City of Plymouth Planning Commission Regular Meeting Agenda Wednesday, February 8, 2023 – 7:00 p.m. City Hall & Online Zoom Webinar

RE: : 980 West Ann Arbor Trail – Site Plan Approval Review for Soothing Dental PLLC

Please find below our responses (in **bold**) to the comments received from the Plan Review Letters provided by Carlisle Wortman and Wade Trim dated January 5th and 3rd respectively.

**Site Plan Review
For
Plymouth, Michigan**

VEHICLE TURNING MOVEMENT PLAN

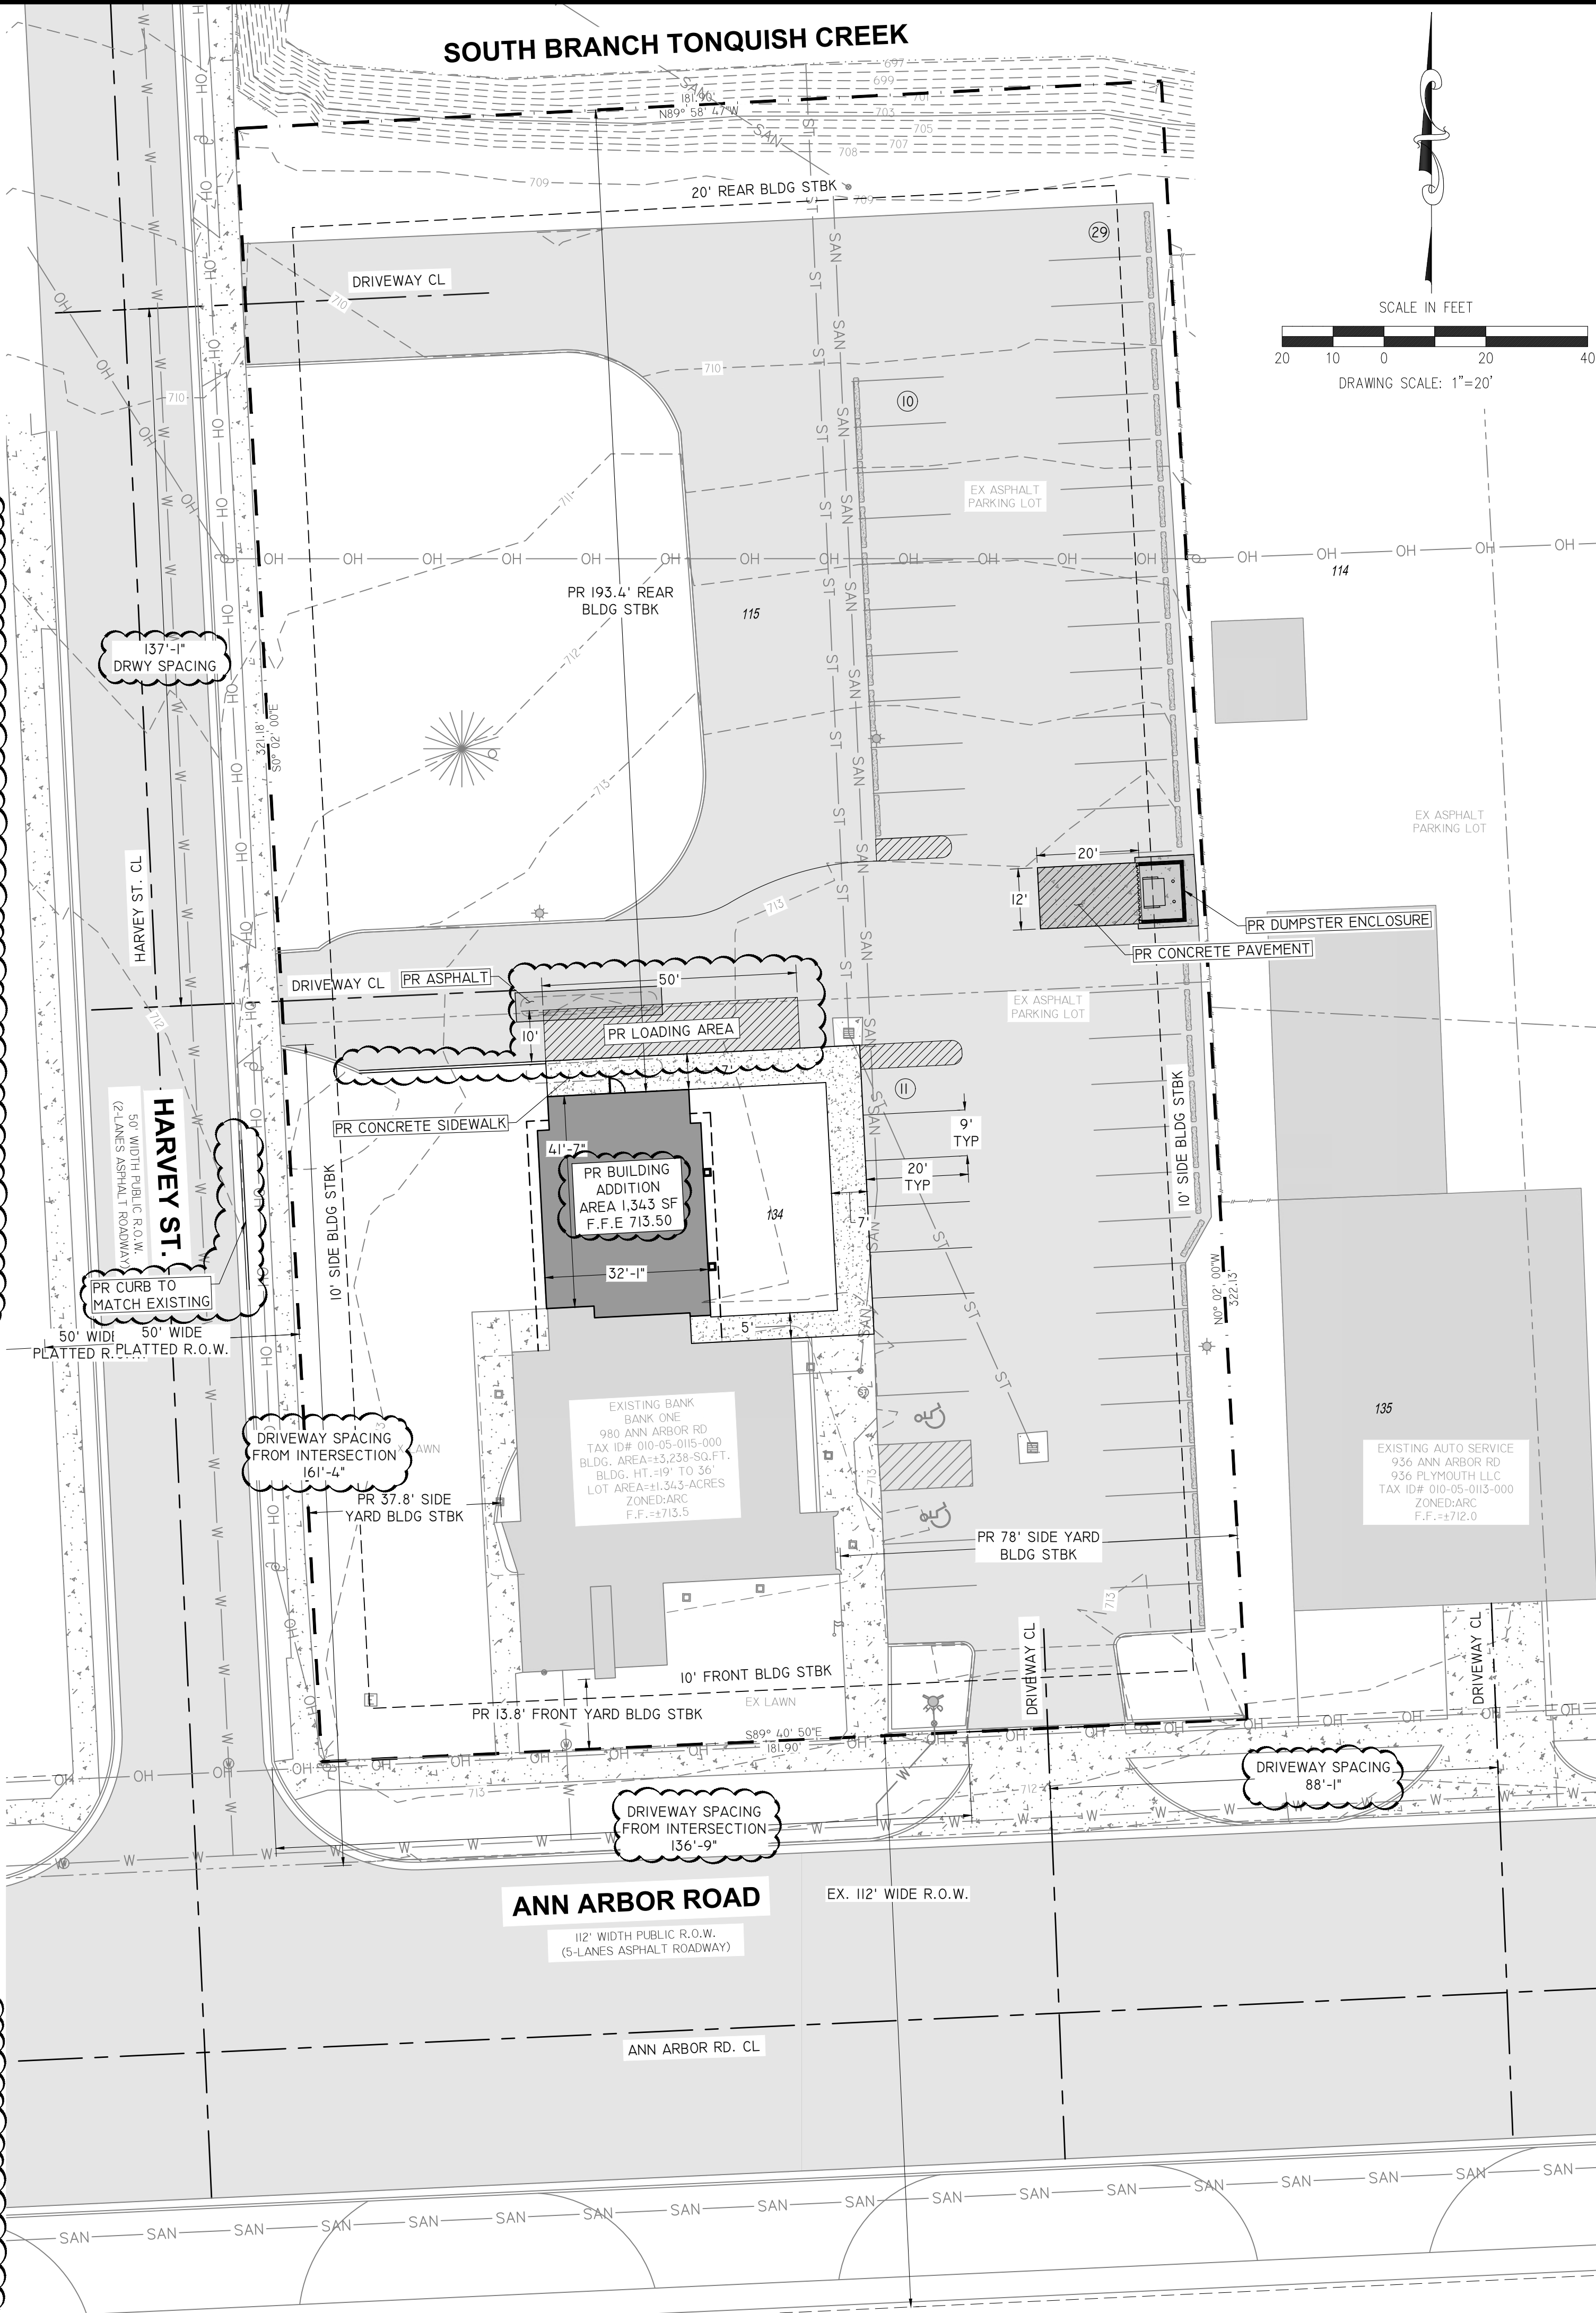
1. The applicant should indicate if they receive delivery of materials. If so, the type and size of delivery truck typically visiting the dental office should be provided. Also, Sec. 78-163 requires one loading/unloading space, indicated on the site plan, for Phase I and Phase II of the project. This space (10' x 50') should be shown on the plans. Revise site plans to show location of one 10' x 50' loading/unloading space.
Loading area have been shown on the site plan. A vehicle turning movement for a SU-30 truck has been added to the plans. Phase 2 has been removed from the plan set.

1. Planning Commission to consider alternatives to driveway spacing from intersection/neighborhood driveway.
We respectfully request the planning commission consider the alternates to driveway spacing as proposed. Southern most driveway on Harvey Street is proposed to be removed as part of the improvements. All remaining driveways are existing, and the existing non-conformities have been significantly reduced.
2. Planning Commission to consider requiring elimination of most southerly drive on Harvey St. as part of Phase I of the project to improve compliance with ordinance requirements.
Southern most driveway on Harvey Street has been removed as part of proposed improvements.
3. Illustrate how a delivery truck will traverse the site, where it will park, and what type of truck will be used for regular deliveries.
A vehicle turning movement for a SU-30 truck has been added to the plans.

SHEET NUMBER: **C3.0**

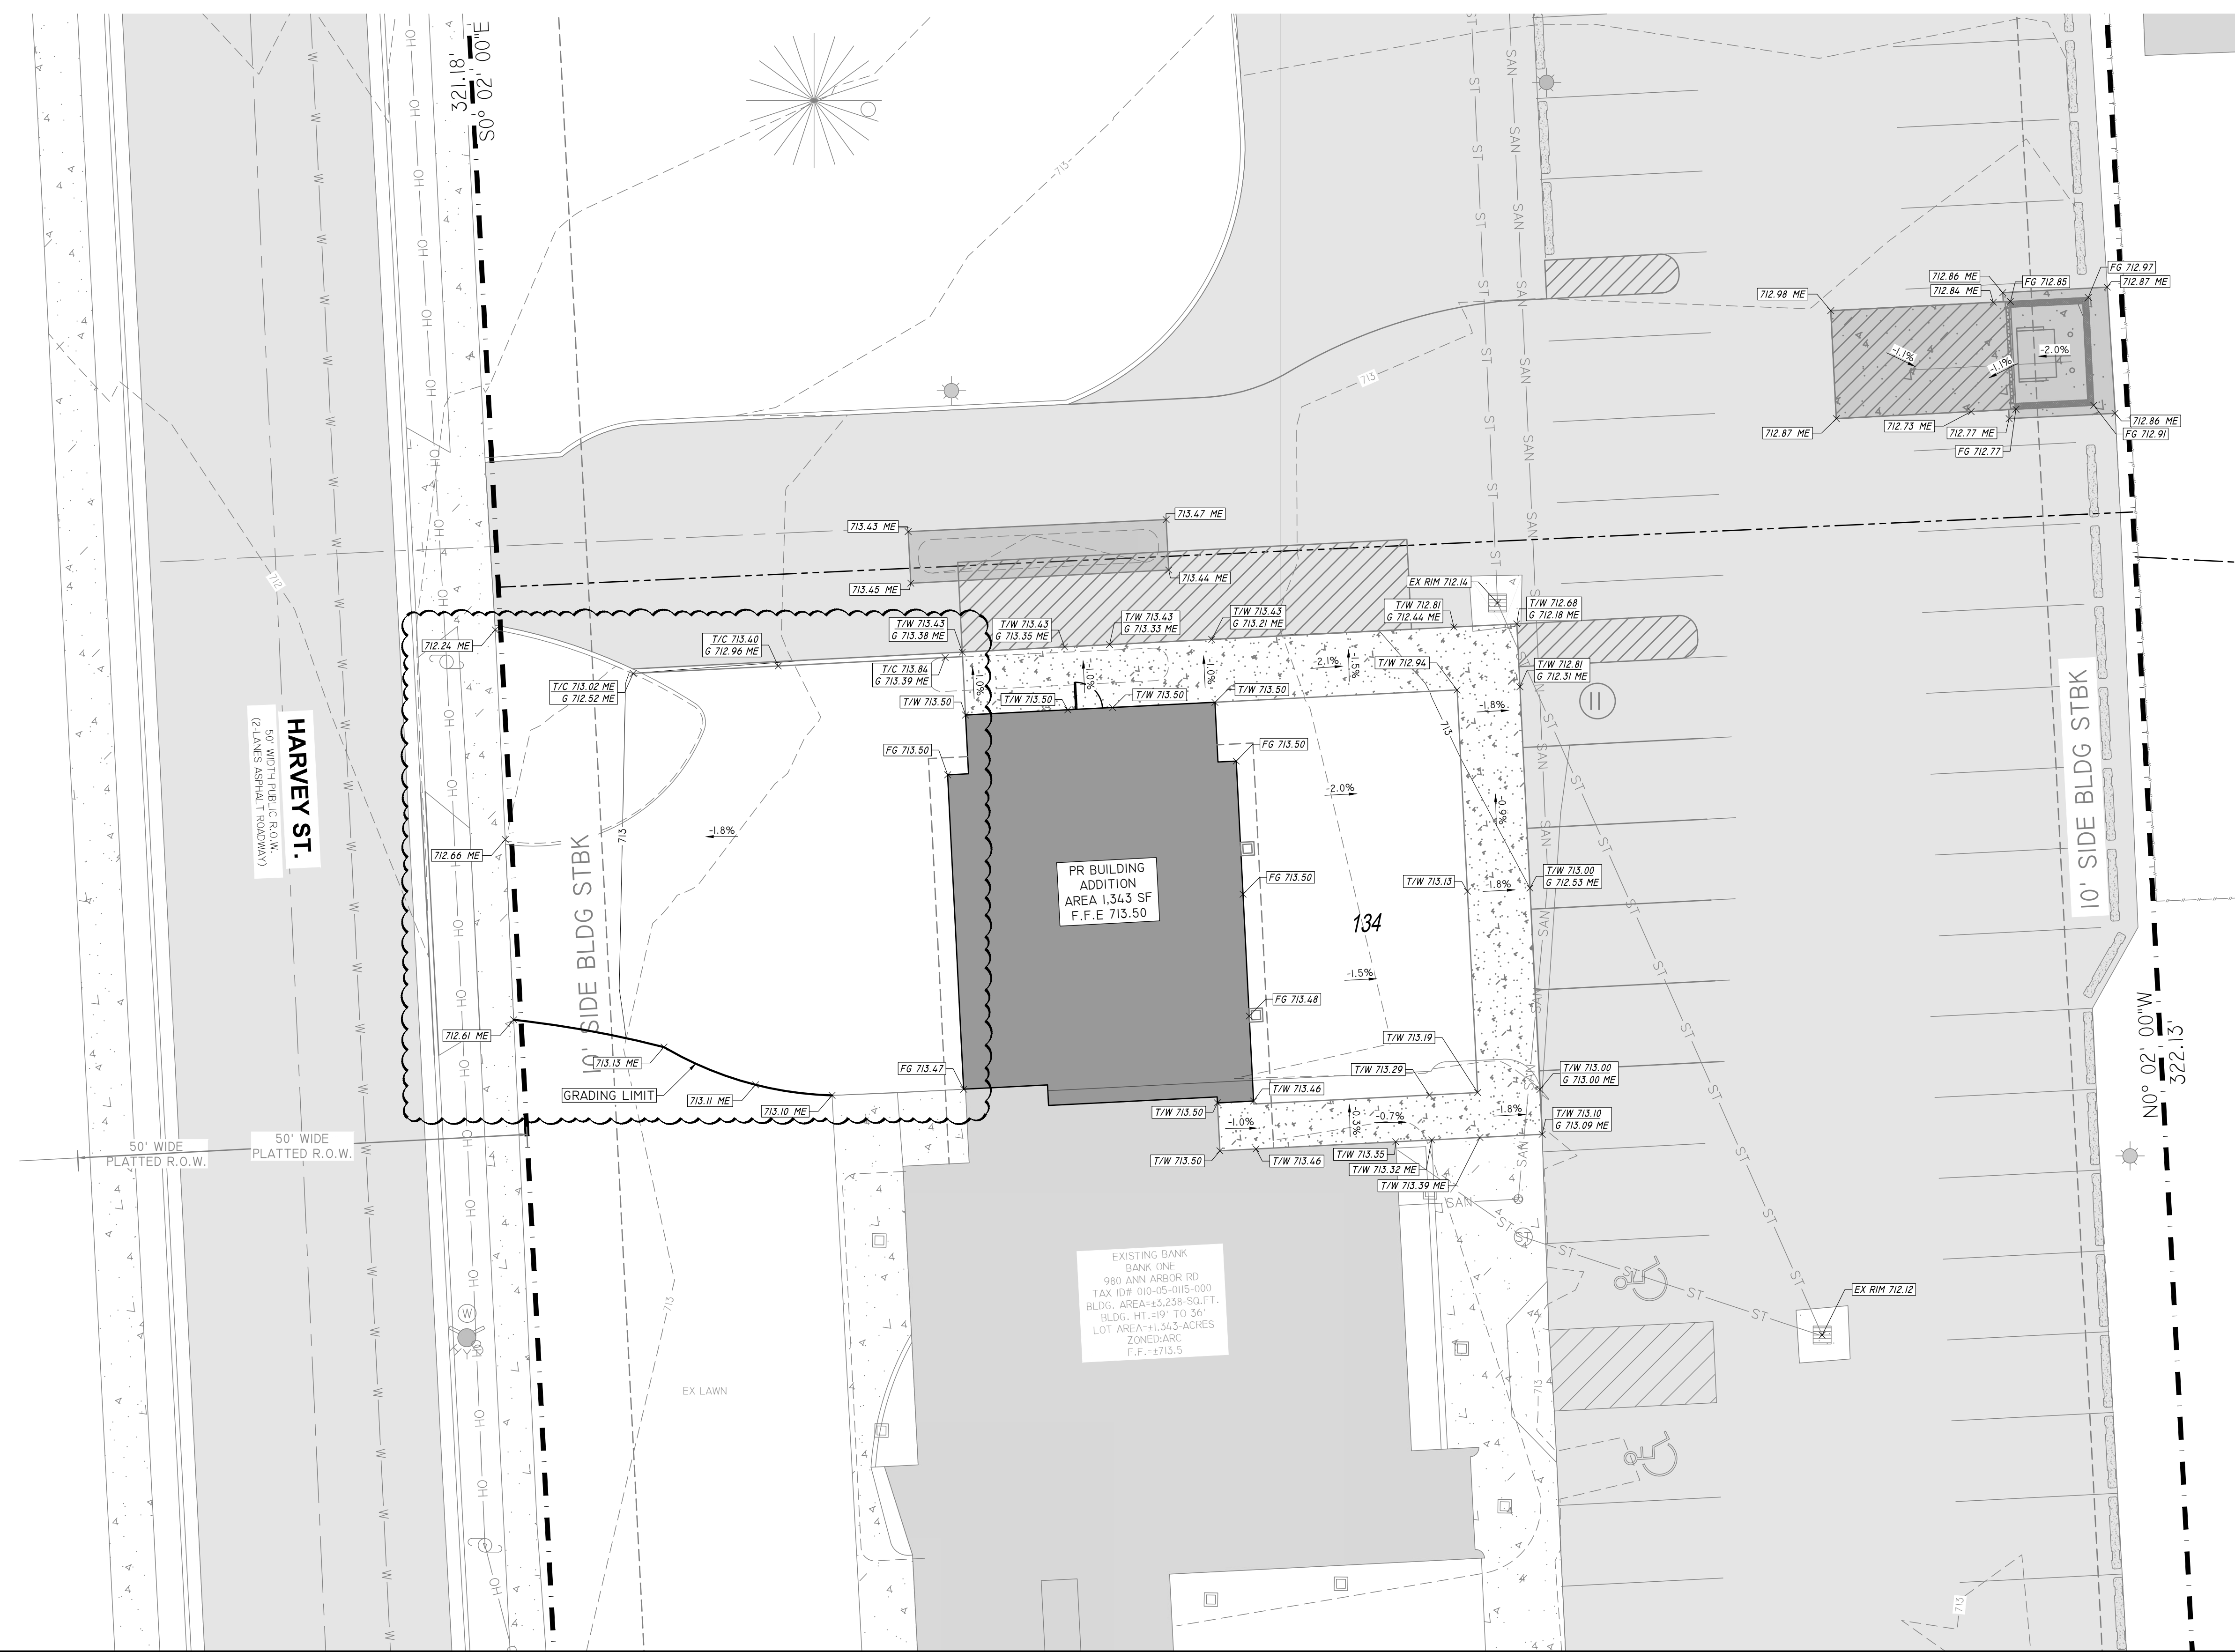
1. Existing Building: Site Data Table (Sheet C3.0) and label on plans are inconsistent. Site Data Table shows existing building is 3,328 s.f.; label on plans shows existing building is 3,238 s.f.
Site data table and labels on plans have been made consistent.

2. Proposed Building Addition (Phase I). Site Data Table (Sheet C3.0) and label on plans are inconsistent. Site Data Table shows proposed addition is 1,343 s.f.; label on plans shows proposed addition is 1,294 s.f.
Site data table and labels on plans have been made consistent.

3. Side Setback. Site Data Table (Sheets C3.0 and Sheet C3.1) and scaled dimensions on plans are inconsistent. Site Data table shows proposed addition located at 78-feet from east property line; but plans scale at 101-feet. Site Data table shows proposed new building located at 75.916-feet from east property line; but plans scale at 85-feet.
Site data table and labels on plans have been made consistent.

As requested, Sheet C3.0 illustrates how a delivery truck will traverse the site, and also shows a loading/unloading zone. In addition, Sheet C3.0 shows how a trash hauler will access the dumpster and traverse the site, as well as fire truck access.

A dumpster screen that completely screens this area from the view of the street is required. Details of the proposed dumpster screen are shown on Sheet C3.0. The outside façade of the screen is 5.67-foot of brick to match the building, topped with coping, and then a 2-foot tall decorative fiber-cement fiberboard and decorative metalwork.

C5.0

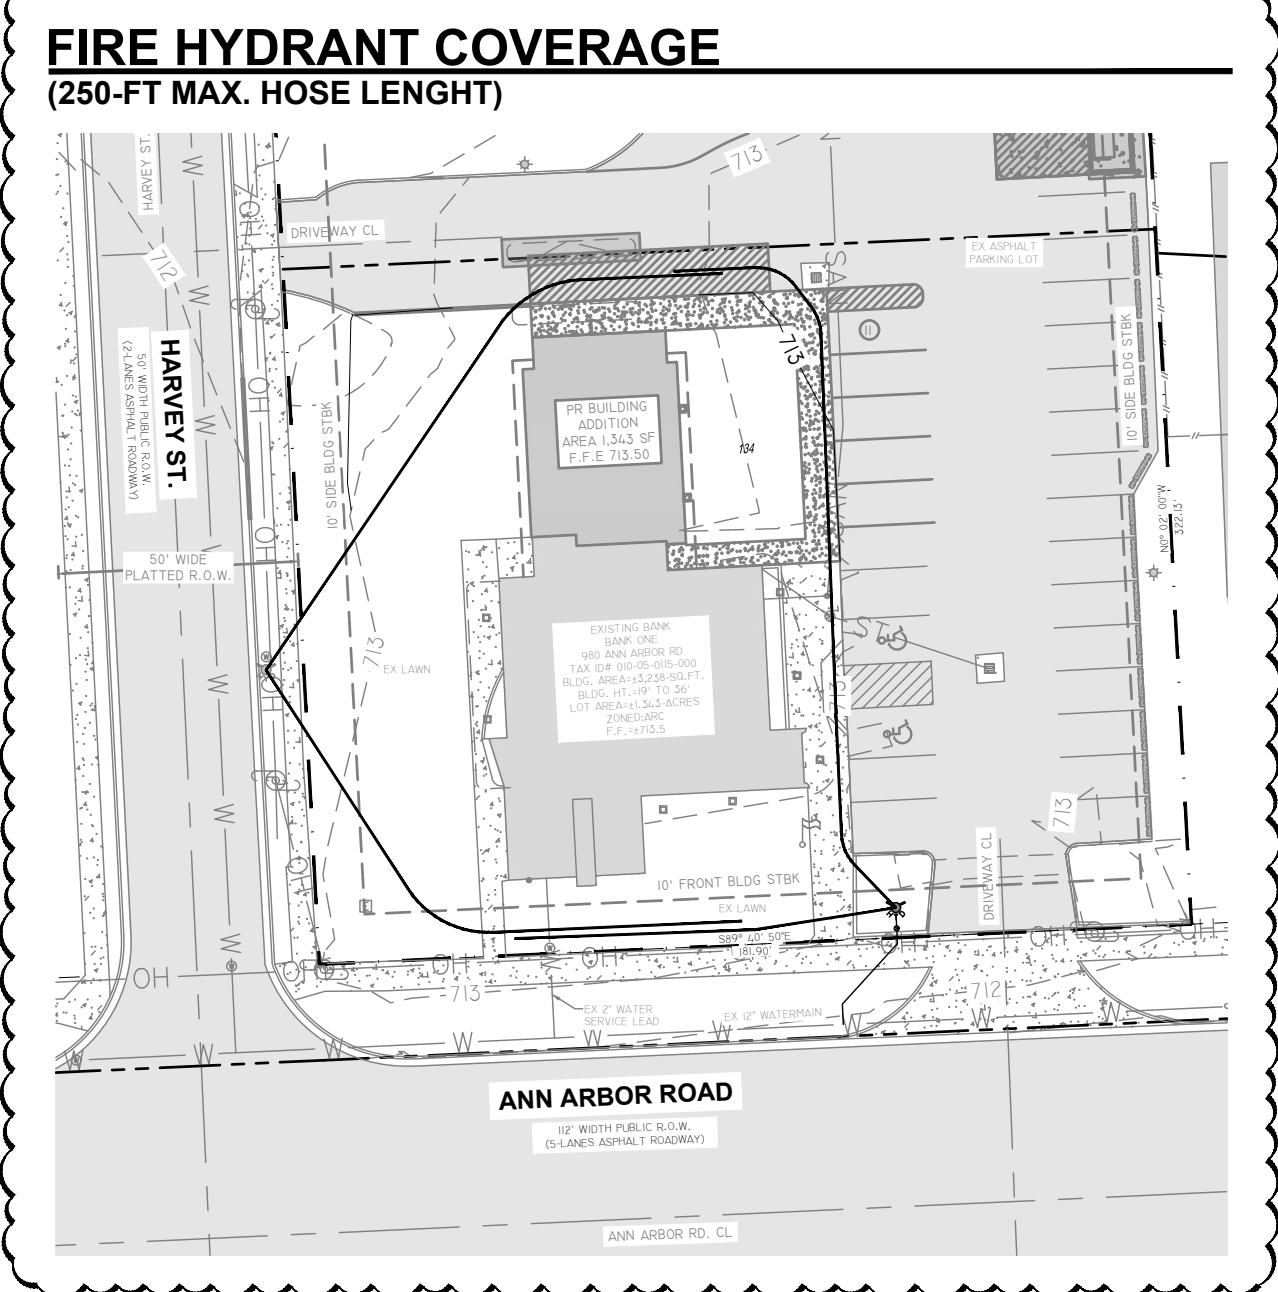
1. Sheet C3.0 shows that existing catch basins will be used to capture stormwater runoff from the new building addition (Phase I). For Phase II, Sheet C3.1 shows a storm line discharging stormwater directly to Tonquish Creek. We assume some type of pre-treatment will be required per the Wayne County Stormwater Standards. We defer evaluation of the proposed utilities to the City Engineer.

7. The site plan does not currently propose a storm water detention.

8. The site plan should be updated to include a storm water detention and management plan that meets the City's storm water ordinance.

The existing site does not provide the required detention storage. It provides storage by 6" of ponding in the parking lot. Phase 1 improvements have reduced the detention requirement. Therefore, no detention storage has been provided other than the parking lot ponding.

Stormwater management plan has been included in the plan set which provides stormwater quality treatment.

ALTHOUGH, DETENTION STORAGE PROVIDED AS 6" OF PONDING IN PARKING LOT HAS BEEN REDUCED BY 33.48 CF, THE DETENTION REQUIREMENT HAS BEEN REDUCED BY 321.75 CF AS THE RUN-OFF COEFFICIENT HAS BEEN REDUCED FROM 0.78 TO 0.75. THE 10-YEAR PEAK FLOW HAS BEEN REDUCED BY 0.17 CFS. THERE IS NO SIGNIFICANT CHANGE DUE TO PROPOSED IMPROVEMENTS WITH RESPECT TO STORMWATER OUTFLOW FROM THE SITE. THEREFORE, NO STORMWATER IMPROVEMENTS HAVE BEEN PROPOSED AS PHASE 1 IMPROVEMENTS.
